Technical Service Bulletin Number	Revision Level	Date	Group Number
TSB140060

Intake Manifold Temperature Sensor Causing Fault Codes 155 and/or 2964

Figure 2

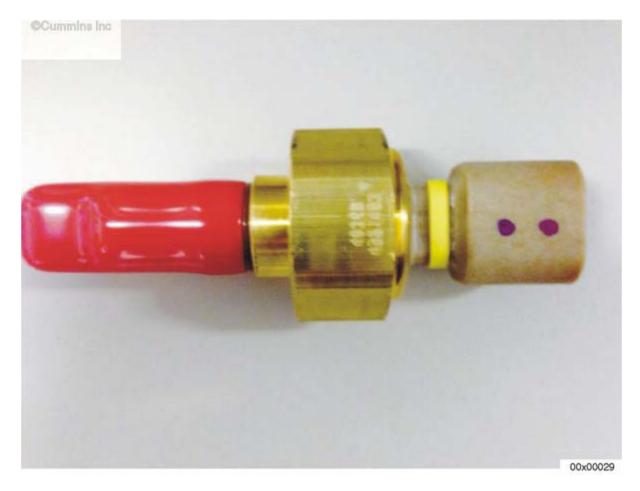
Screening and certification of Cummins® Part Number 4921483 intake manifold temperature sensors within the affected range began 01 May 2014. Certified parts are marked with two dark-colored dots on the sensor connector body as shown below in Figure 2. On unpainted parts, this marking can easily be identified. On painted engines, however, it may be necessary to carefully remove the paint from this area of the sensor to inspect for certification marking. Other markings in other locations do **not** indicate a certified sensor.

Replace the intake manifold temperature sensor with either a certified part identified by two dark-colored dots marked on the sensor body as shown in Figure 2, or a part produced with a date code later than 01 May 2014 (4121x where "x" represents any shift A, B, or C).
